Subject: Response to letter of April 10, 2008 for additional information concerning application for amendment to license, control no. 141666

Docket: 03010576
License No.: 06-01450-47

Subject: Response to NRC Request for additional information concerning application for amendment to license, Control No. 141666.

*RIA kits **Table of Isotope Usage at Nyank- See Timeline on page 3**

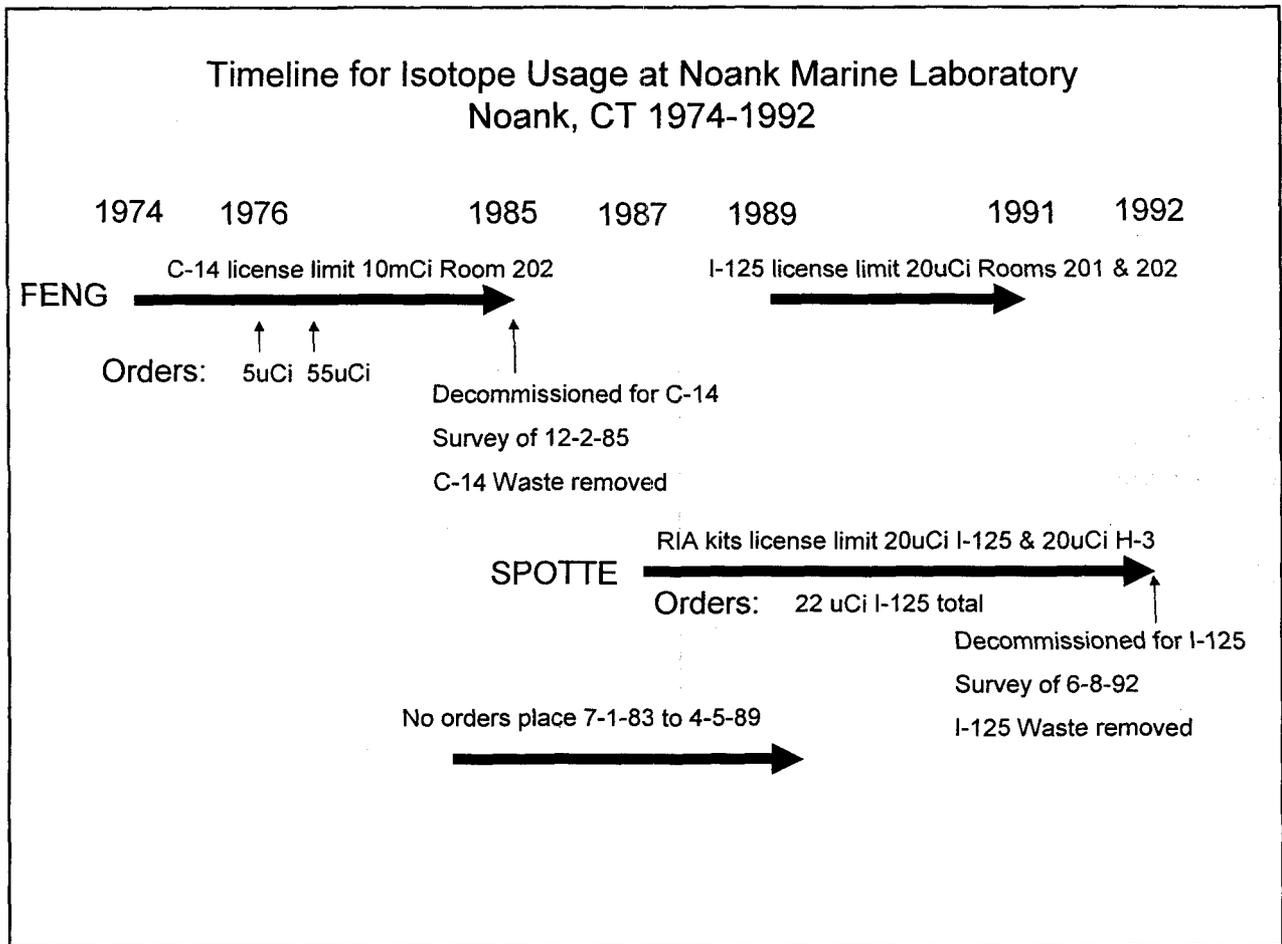
1b. Your letter indicates that Sung Yen Fang, Ph.D. conducted licensed activities in Rooms 201 and 202 with carbon-14 in an unsealed form. The letter also indicates that Stephen Spotte, Ph.D., used iodine-125 in an unsealed form in an unspecified room.

Please confirm whether any other isotopes were used at the facility, the time frame in which materials were used, the amount of licensed material ordered and used for experiments, and the rooms used by Dr. Spotte and any other researchers.

Isotope	Time frame	Quantity/Order	Investigator	Room(s)
C-14	1974-1985	5 uCi (4/26/76) 55 uCi (5/12/76)	Feng Feng	201/202
Ni-63**		30 mCi sealed sources	Feng	
I-125*	1987-1992	5 uCi (8/6/91) 5 uCi (9/3/91) 4 uCi (9/6/91) 4 uCi (10/4/91) <4 uCi (1/27/92)	Spotte	201
H-3*	1987-1992	(No usage indicated Licensed for 20 uCi)	Spotte	201
Co-60** Ra-226**	1977-1988	200uCi sealed source 25uCi sealed source	Madasci

The data under Quantity/Order were based on order logs and quarterly inventories. (See Appendices SPOTTE-A, SPOTTE-B, and FENG).

Room usage: Records indicate Feng used C-14 inulin in Room 202.

DIAGRAM OF SURVEYED AREA

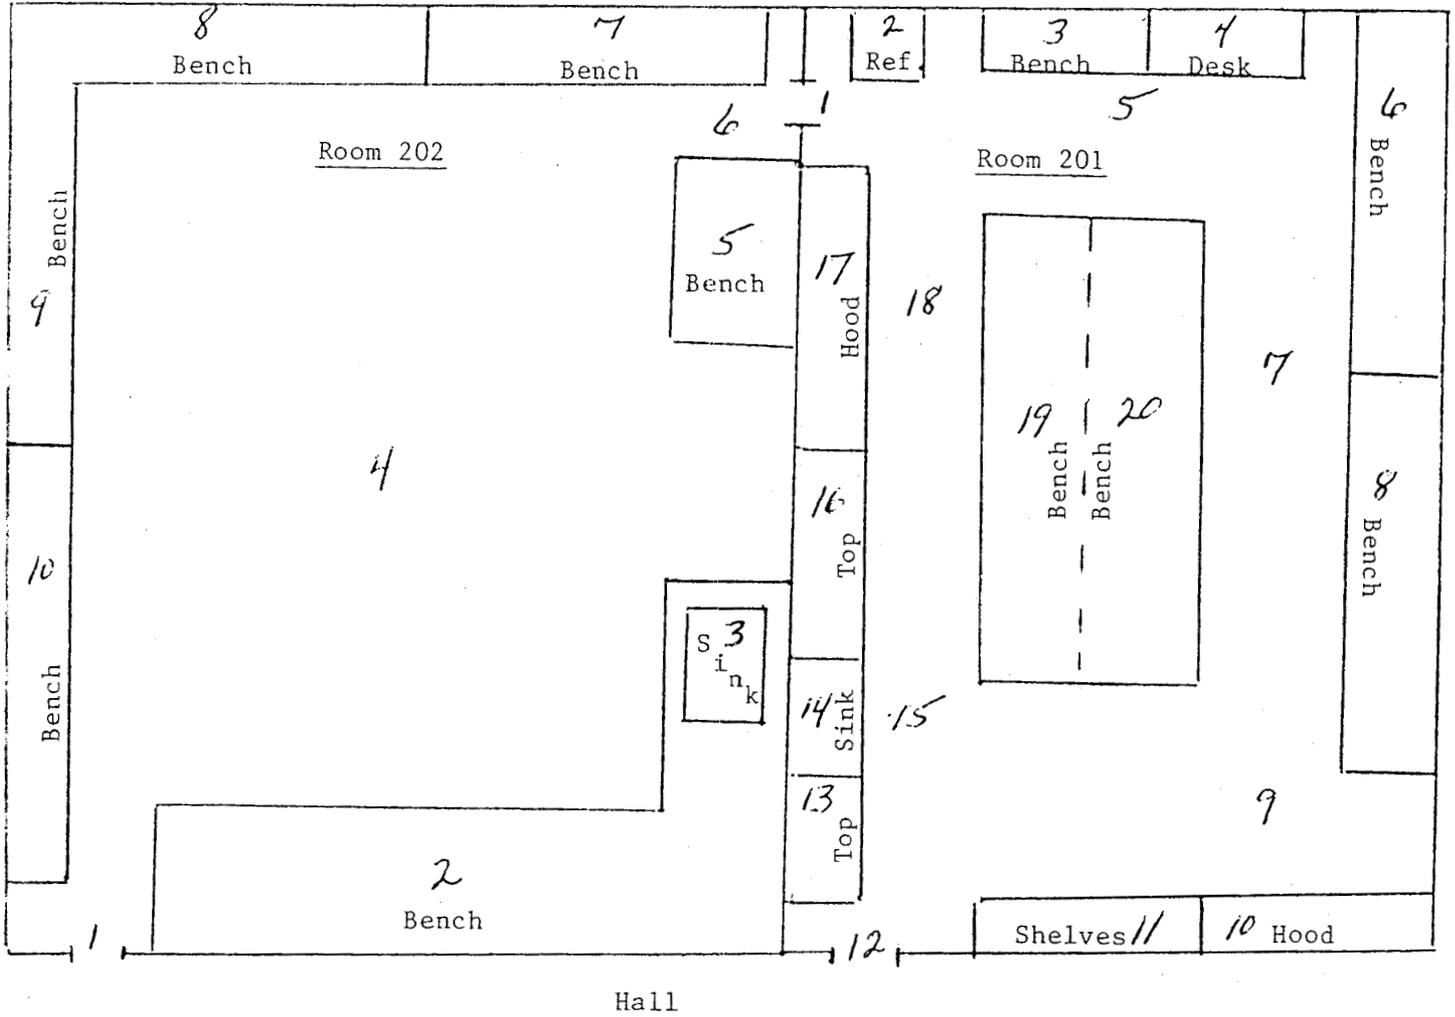
1.d. Indicate whether there were any sewer disposals and/or effluent releases at the facility. Your surveys should include the sinks, drains, ductwork and areas where radionuclides may aggregate.

Decommissioning surveys performed on January 21, 1986 (for C-14) and June 16, 1992 (for I-125) covered a number of sites of possible aggregation and all wipe tests were within background.
